## Delegated Action of the Executive Director

<b>PROJECT</b> <b>Arlington National Cemetery Memorial Avenue Pedestrian Crosswalk Relocation</b> 1 Memorial Avenue Arlington, Virginia	<b>NCPC FILE NUMBER</b> 8174
<b>SUBMITTED BY</b> Arlington National Cemetery	<b>NCPC MAP FILE NUMBER</b> 1.61(00.00)45122
	<b>ACTION TAKEN</b> Approve preliminary site development plans
	<b>REVIEW AUTHORITY</b> Approved Per 40 U.S.C. § 8722(b)(1)

Figure 1: Site plan showing location of existing and proposed Pedestrian Crosswalk.

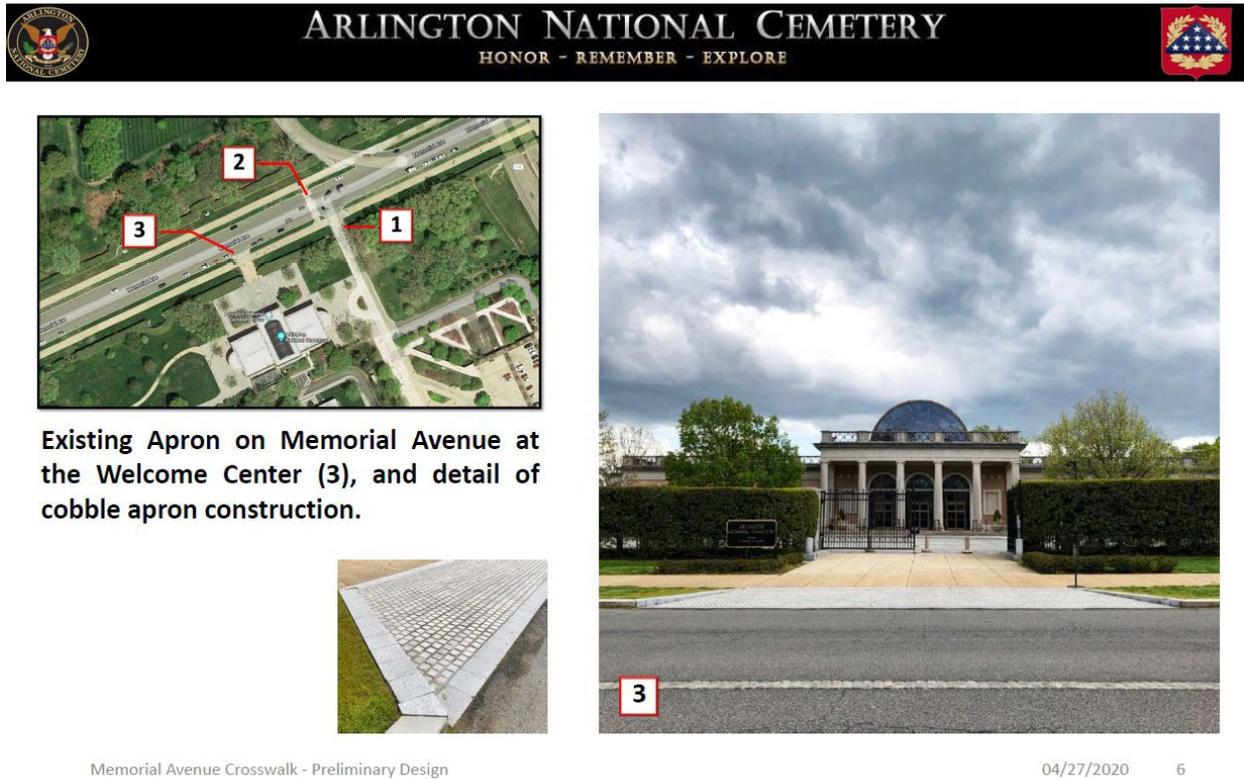
Overall, staff finds the proposed relocation will better accommodate visitors by directly aligning the crossing with the Visitor Center. It will also move the crosswalk away from an intersection where vehicles are turning. Therefore, staff finds the proposed plans for the relocation of the pedestrian crosswalk on Memorial Avenue provides a safer location for visitors to access Arlington National Cemetery’s Welcome Center. This is consistent with the policies set forth in the Visitor, Transportation and Historic Preservation Elements of the *Comprehensive Plan for the National Capital*.
